RESERVE AT THE
BALLPARK, PHASE II,
AKA REVEL AT THE
BALLPARK
2885 CRESCENT PKWY
SMYRNA, GA 30080

SHEET TITLE OVERALL ROOF PLAN

A2-00

COMMENTS BUILDING PERMIT RE-SUBMISSION

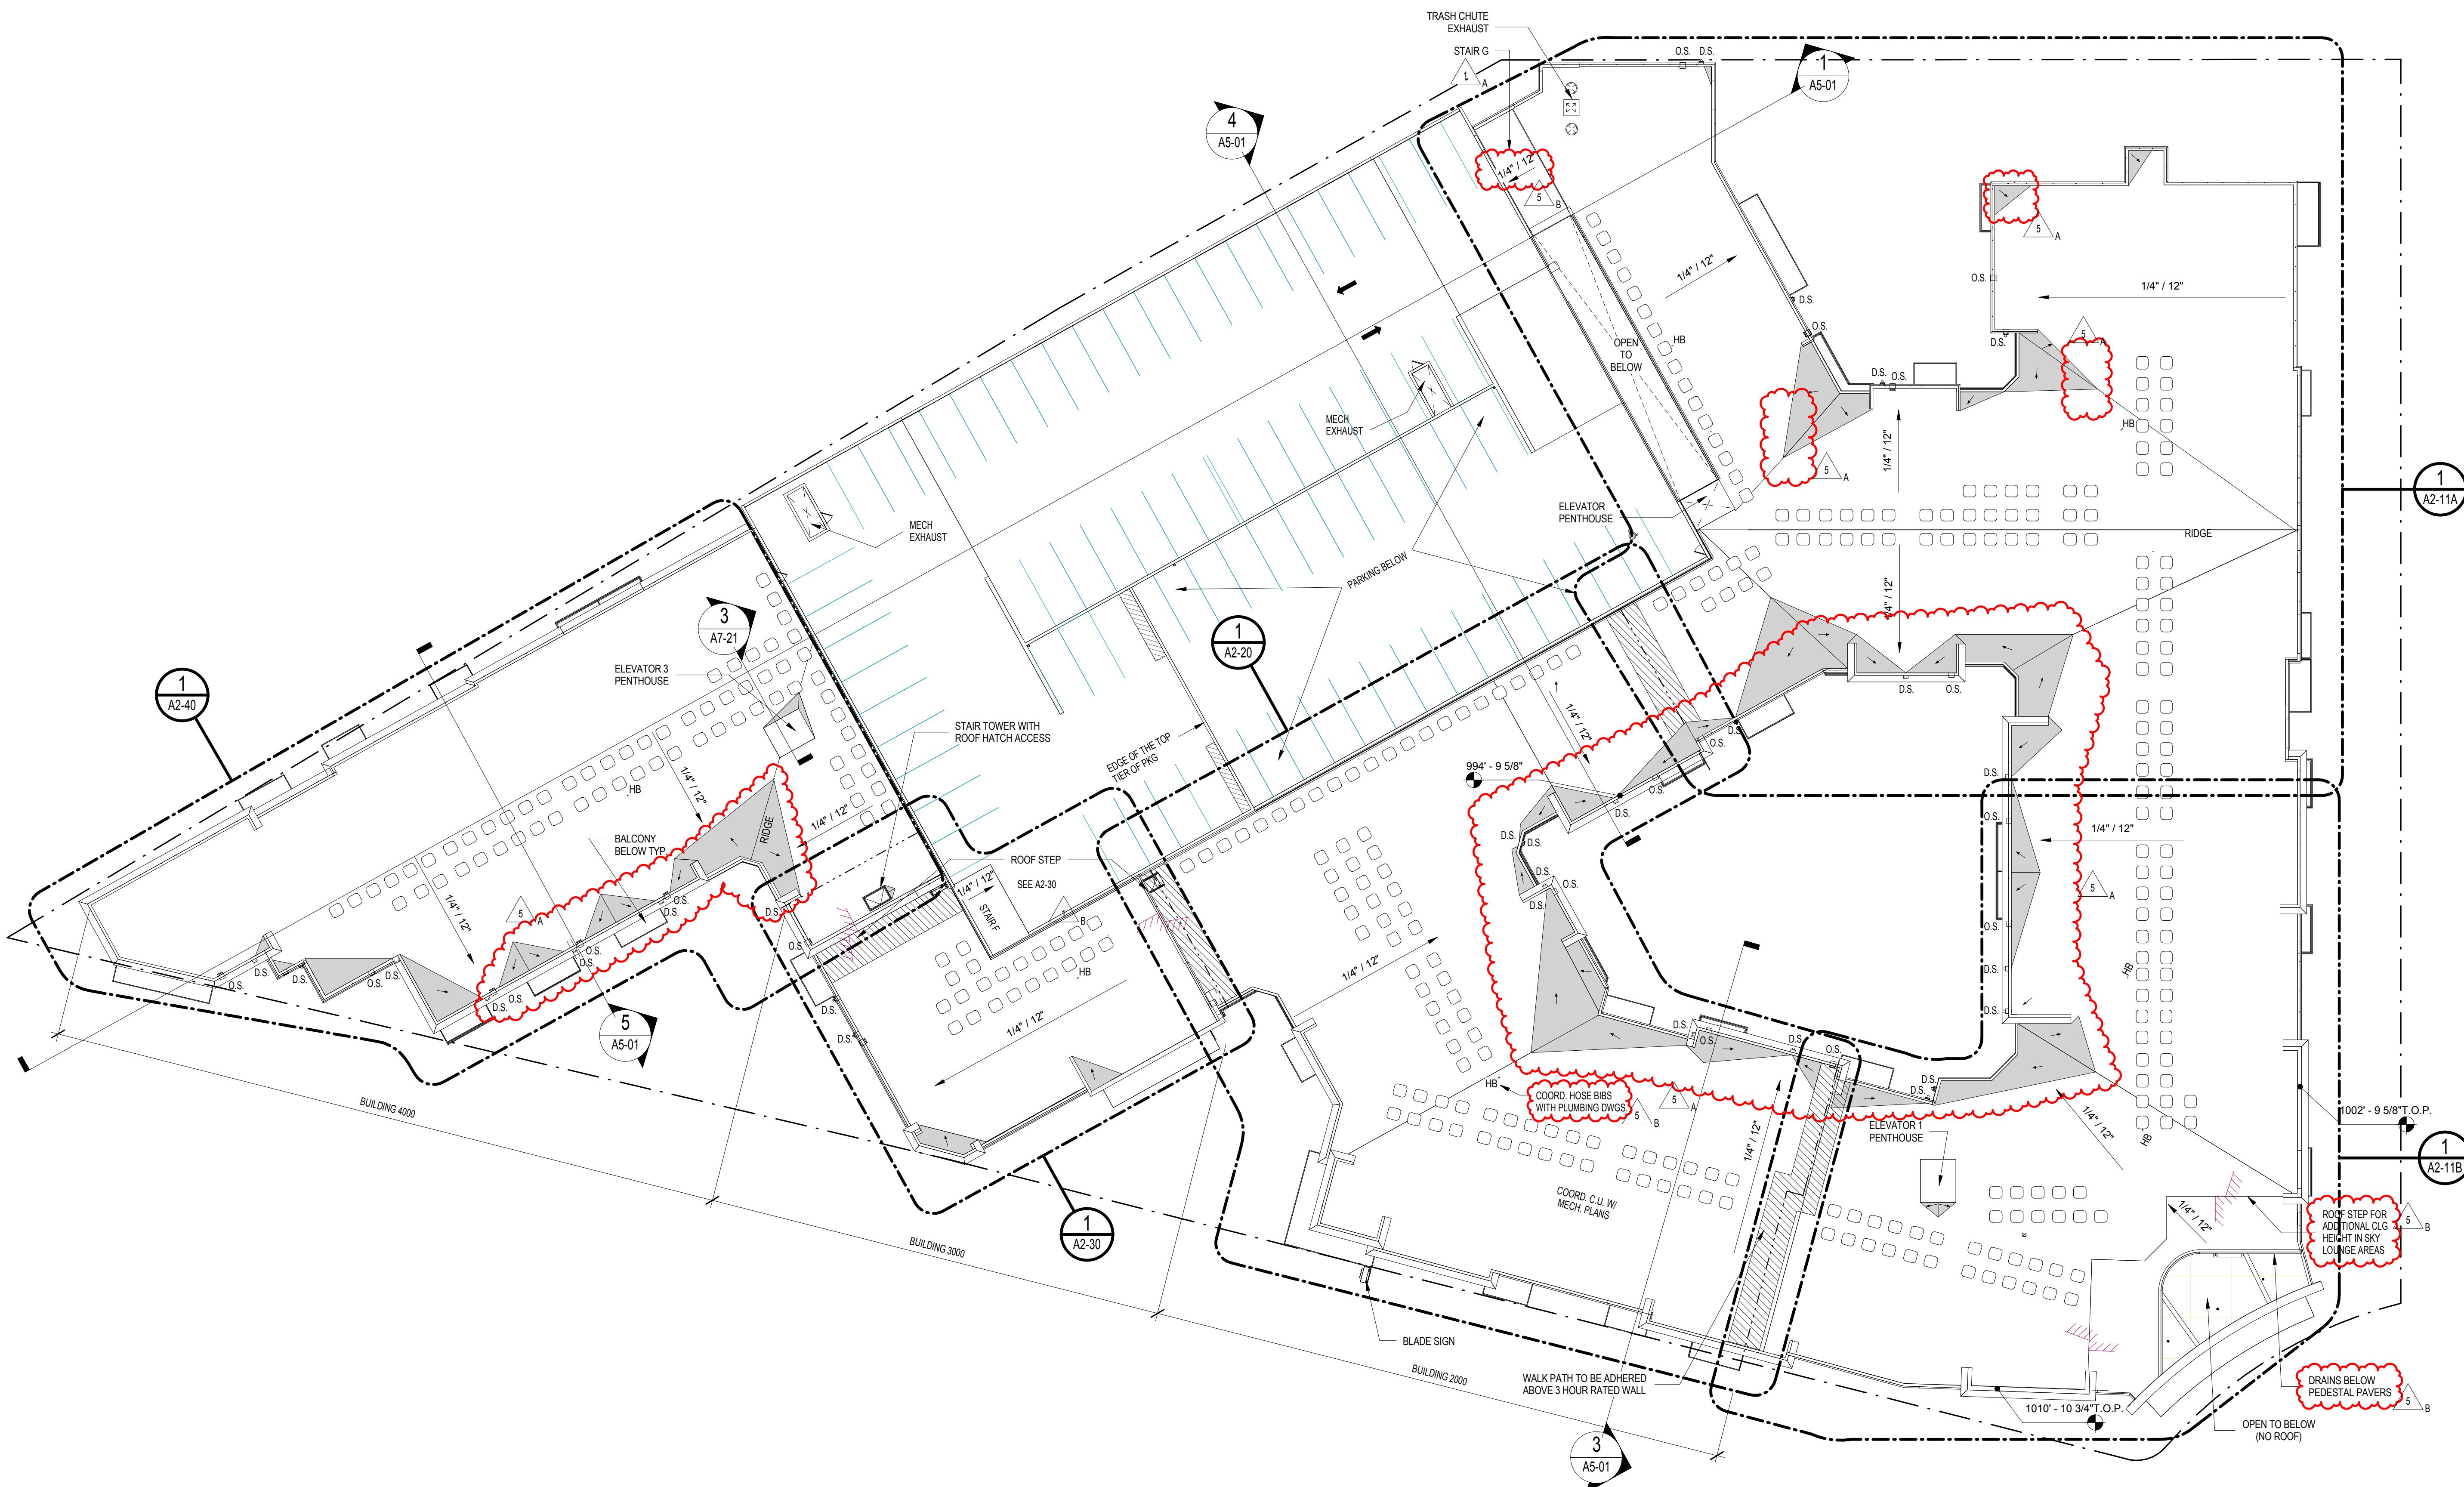
REVISION SUMMARY #5

A. ROOF CRICKETS REVISED, DOWNSPOUT ADDED
B. NOTES ADDED
